Access Compliance Report

Public Rights-of-Way

(Pedestrian Signals)

Intersection ID: N/A	Main Street:	Cross Street: N/A	Location: N/A
ADA ID: 20C6DBAC91DF	Signal Type: Two Push Buttons-Non APS	Overall Compliance: No	Severity Score: BTN 1:N/A BTN 2: N/A No BTN: N/A
Codes/Mitigation Info/Possible Solution		Field Measurements/Component Compliance

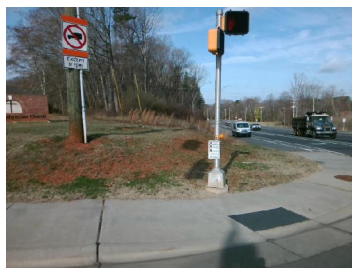
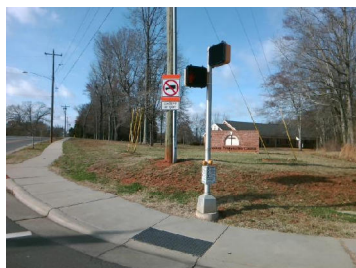
PROW/ADA: R404.2, R404.3, R404.7.2

Possible Solutions: Remove and Replace Clear Space.
